**UPGRADE OF KLAARSTROOM OXIDATION POND  
WASTEWATER TREATMENT SYSTEM**

**COMMENTS AND RESPONSE REPORT**

**DATE: APRIL 2019**

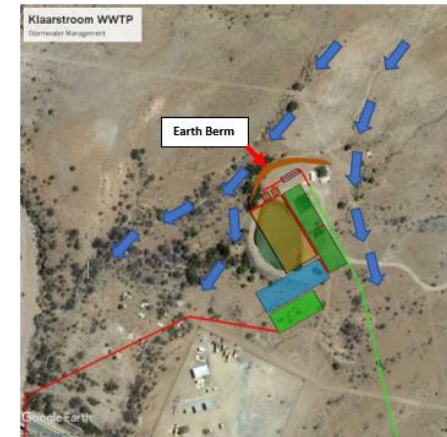
<p>Conservation of Agricultural Resources Act, 1983 (Act No. 43 of 1983) (“CARA”), landowners must prevent the spread of alien invasive plants on the property. The level of alien infestation is therefore not be seen as reducing the sensitivity of a site, nor is the subsequent removal of alien vegetation from a property regarded as a mitigation measure due to this is being a legal requirement. Infestation by alien does not necessarily mean that an area is not important for biodiversity as some vegetation types are particularly prone to invasive alien infestation, but may recover when cleared of alien vegetation.</p> <p>3. In addition to CARA, in terms of the Alien and Invasive Species Regulations, NEM:BA, 2014, specific alien plant species (e.g. <i>Opuntia ficus-indica</i>) are either prohibited or listed as requiring a permit; aside from restricted activities concerning, inter alia, their spread, and should be removed.</p> <p>4. Given the location of the facility within a non-perennial drainage line it is unclear how the design would accommodate for potential flash flooding events (which Karoo is know for). It is recommended that an appropriate storm water management plan be compiled to ensure that the infrastructure is adequately protected and</p>	<p>3. Noted and agreed. Condition added in the BAR.</p> <p>4. Gert Meiring from BVI Engineers gave the following response(s):</p> <p>Your concerns in this regard are noted and subsequently we propose that a low earth embankment (1.0m high) be placed on the northern side of the proposed works to channel any stormwater around the proposed</p>	<p>EnviroAfrica</p> <p>Gert Meiring, BVI Engineers</p>

works as indicated on the image below. The primary concentrated runoff from the drainage lines as indicated will then be mitigated. Similarly, the second drainage line from the east could be diverted using a trench along the toe-line of the eastern ponds to ensure that stormwater is diverted to the south of the works.

The Storm water Management Plan is included as Appendix A.
